Bid Addendum

Addendum No. 3 for the City of Staunton Johnson, Byers, and New Street Tunnel Repairs.

Addendum Date: November 10, 2025

CITY OF STAUNTON
JOHNSON, BYERS, AND NEW
STREET TUNNEL REPAIRS
STAUNTON, VIRGINIA

SANITARY SEWER PROFILE A

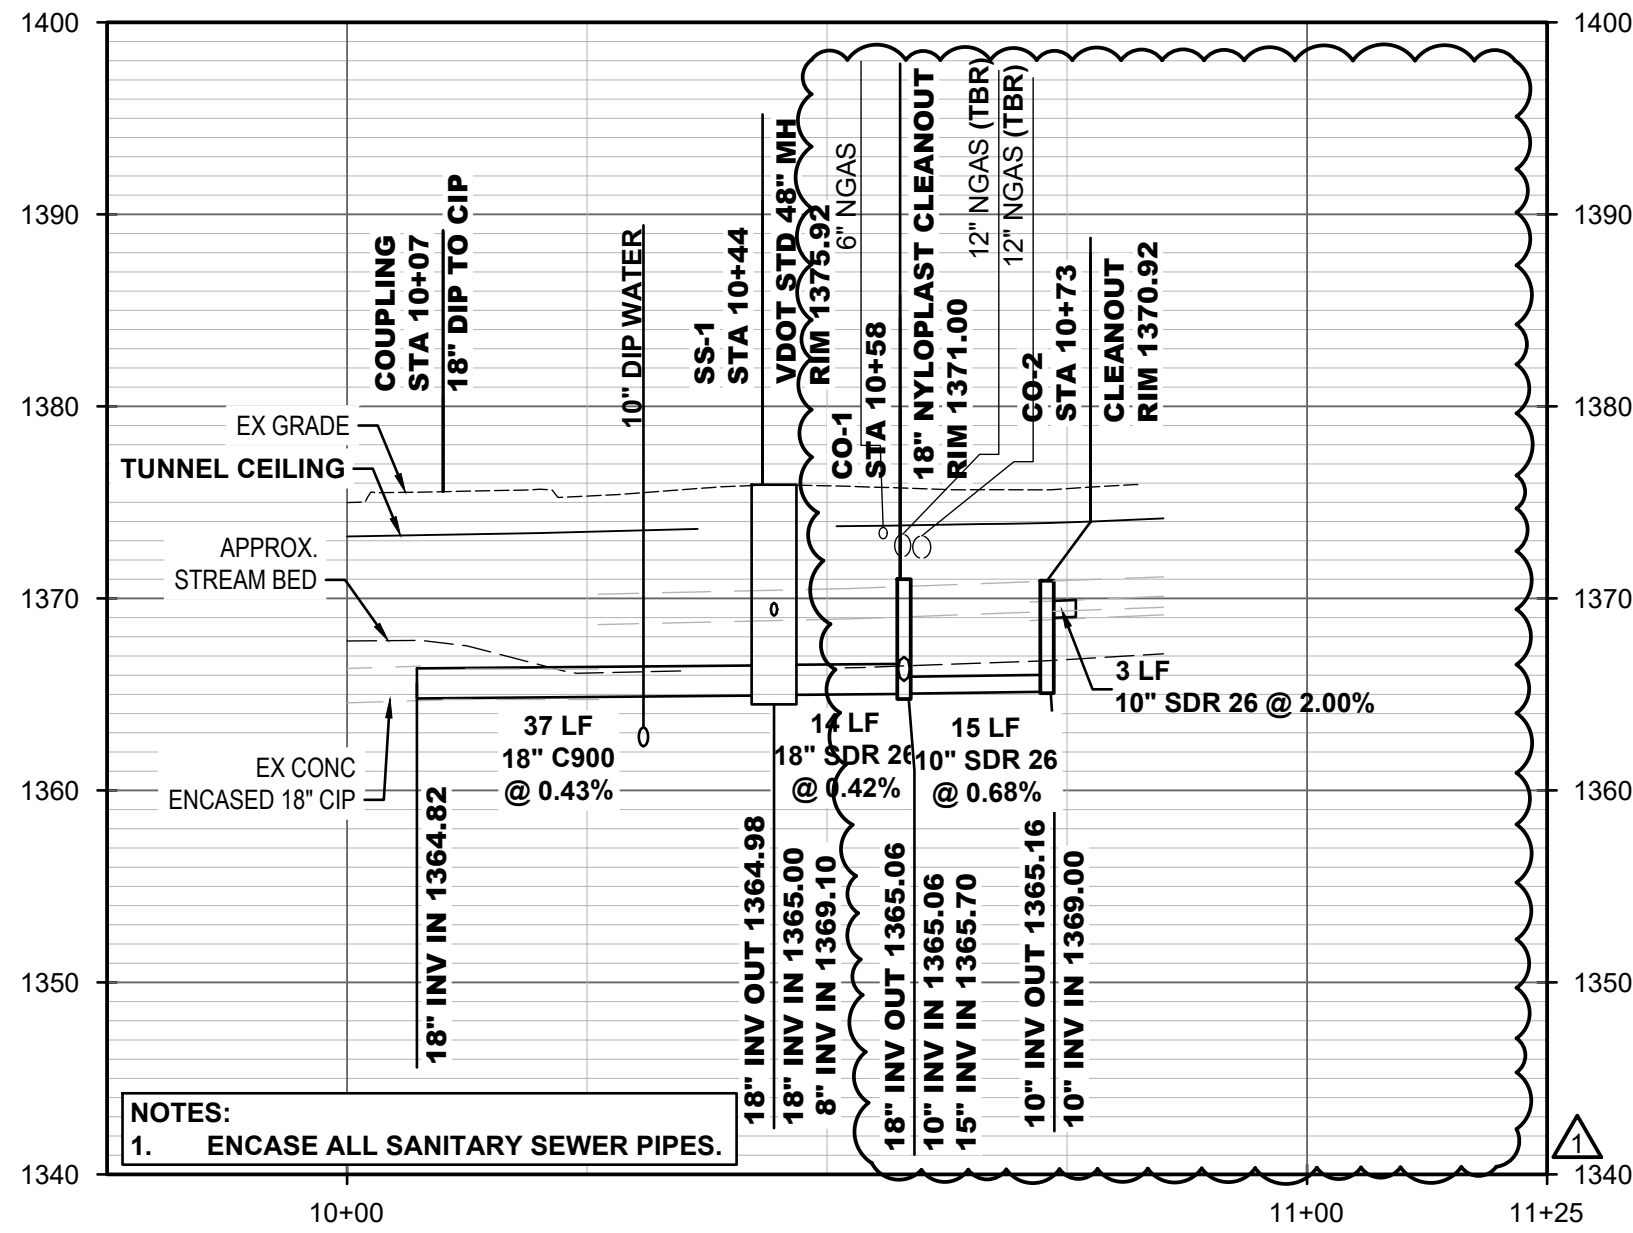
Question 27: Note on plan sheet C-114 says this line is detailed as San Profile A on sheet C-116 but that is incorrect and no profile is given. Can profile for this sewer run be provided?

Drawing C-116: Has been reissued to add “Sanitary Sewer Profile C” and show revisions to the “Gas Relocation Profile”, “Sanitary Sewer Profile A”, and the “Water Line Profile – Johnson Street.”

Response: San Profile A on C-116 shows from the connection of the new 18" C900 sanitary sewer pipe to the existing 18" CIP upstream to SS-1 to CO-1 to CO-2. The references on C-114 have been updated to reference C-116.

SANITARY SEWER PROFILE C

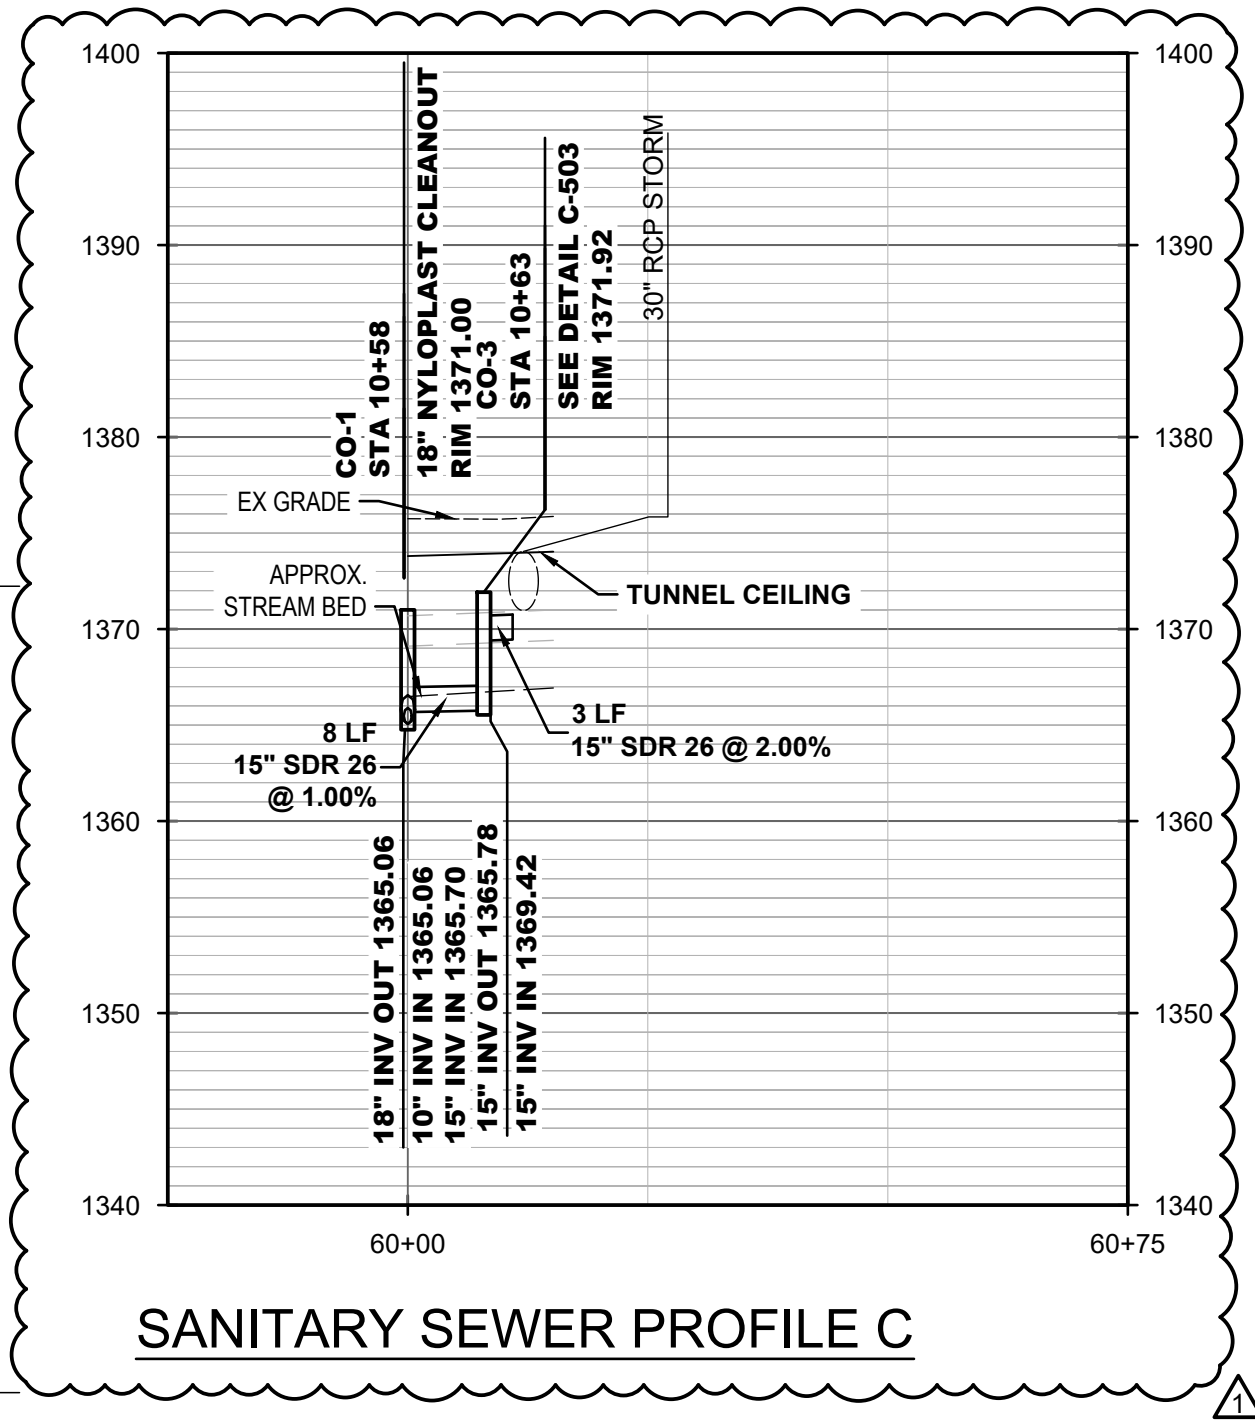
Question 31: The 15" SDR 26 Sanitary Sewer branches off from CO-1 shown in Profile A, sheet C-116. No profile for this line is shown. Can a profile with elevations be provided?

Question 34: 1. No inverts are provided but plan shows top of conc encasement of existing pipe at 1371.46. That is 4' above the top of the stem wall. No dimensions are provided but scaling indicates the C/L of the existing pipe is approximately 2.5' from the face of the new tunnel section. Does Section D6 on sheet S-301 and detailed on Sheet S-501 possibly refer to this 15" SDR? If so, it appears the concrete encasement will extend beyond the edge of footing and the new sewer will need to be installed prior to precast erection south of connection point.

Response: Sanitary Sewer Profile C has been added to C-116

Response: We have revised how this pipe ties into the existing 15" VC. See revised sheets C-114 and C-116 (profile Sanitary Sewer Profile C) and details on C-503. As long as the encasement provides 5" minimum between the face of concrete and the outside of pipe, some overhang of the encasement past the footing is acceptable.

GAS LINE TRENCH

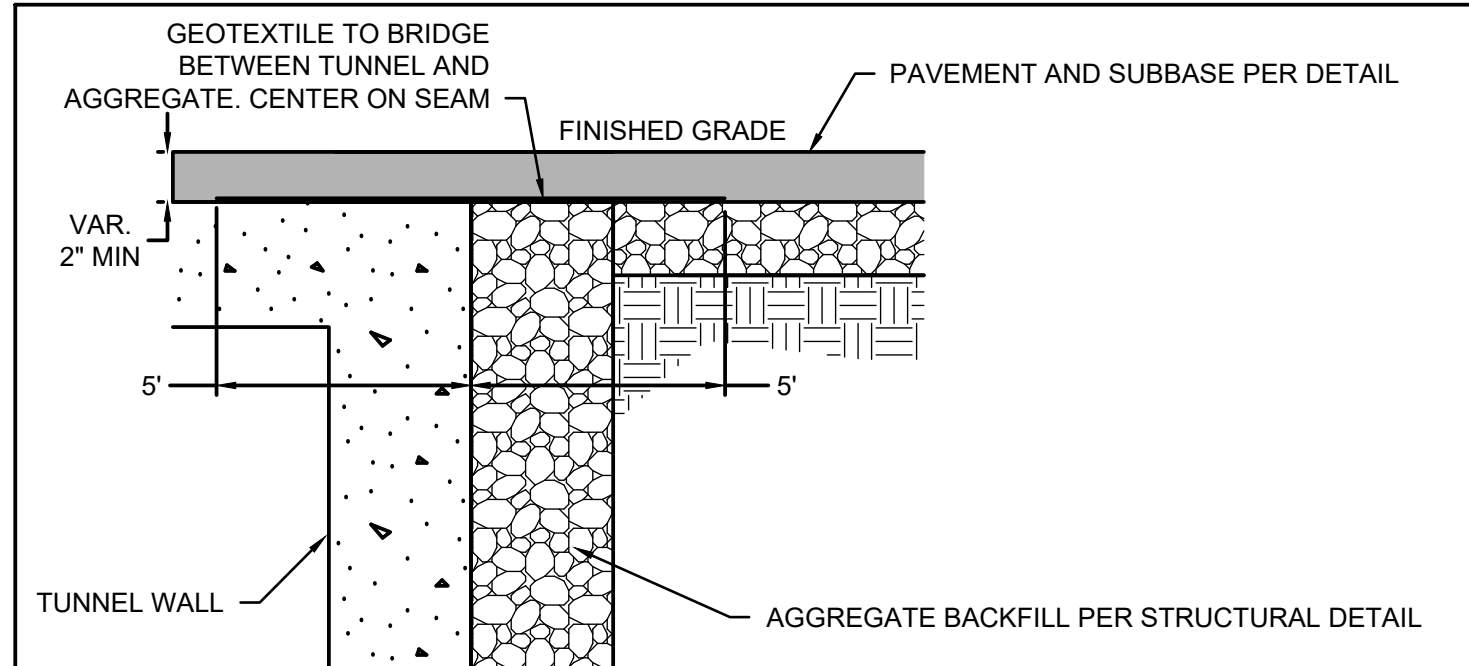
Drawing C-502: Has been reissued to swap the pipe trench and concrete collar detail with C-503 and add a detail for the gas line trench.

SECTIONS - JOHNSON ST CROSSING

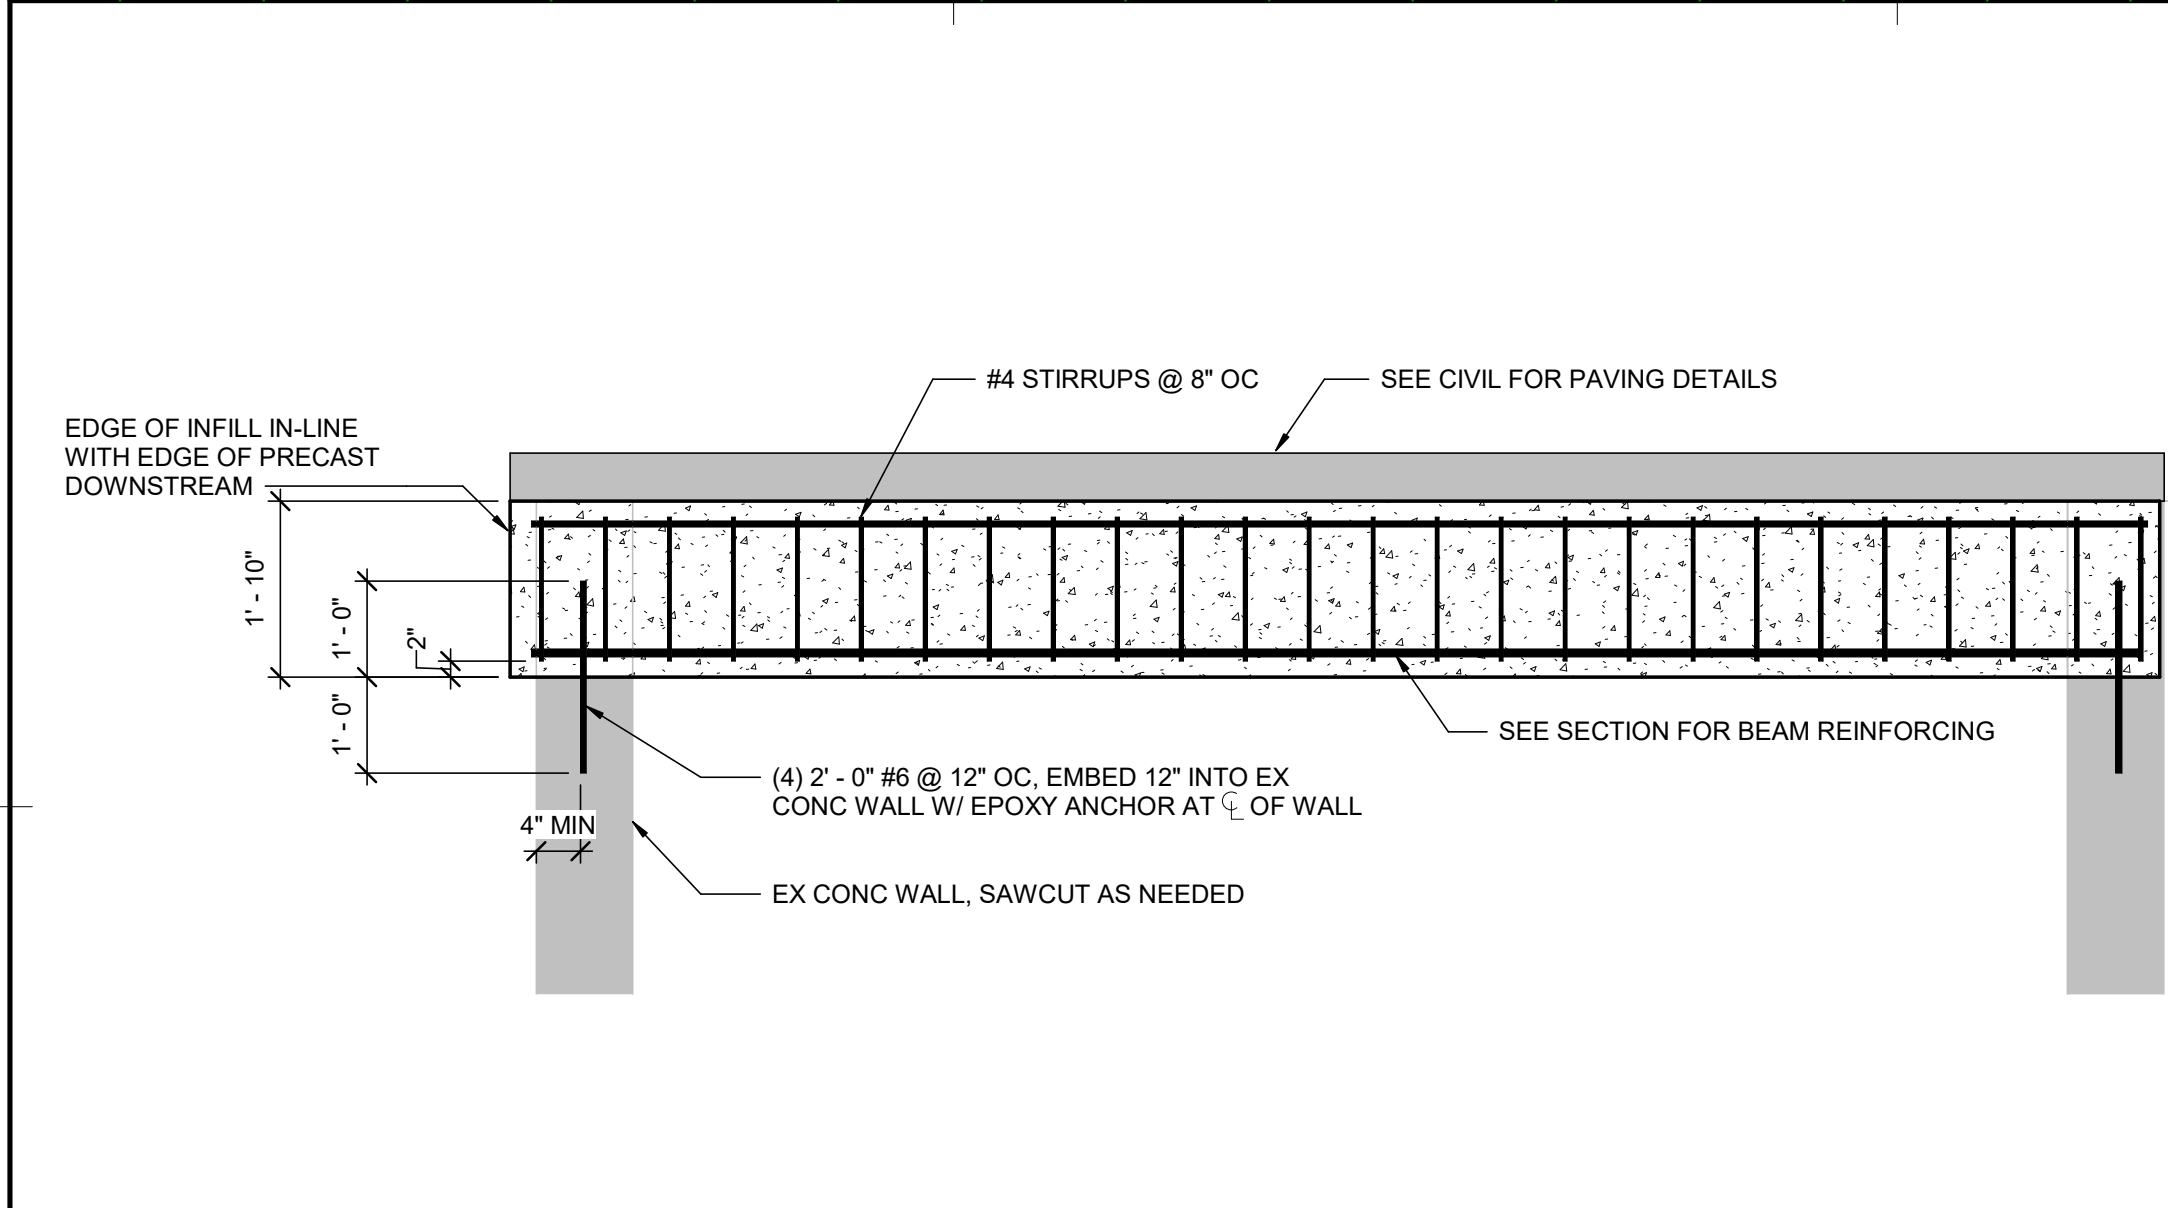
Drawing S-302: Has been issued to include a section of cast-in-place tunnel roof near the garage entrance along Johnsons Street.
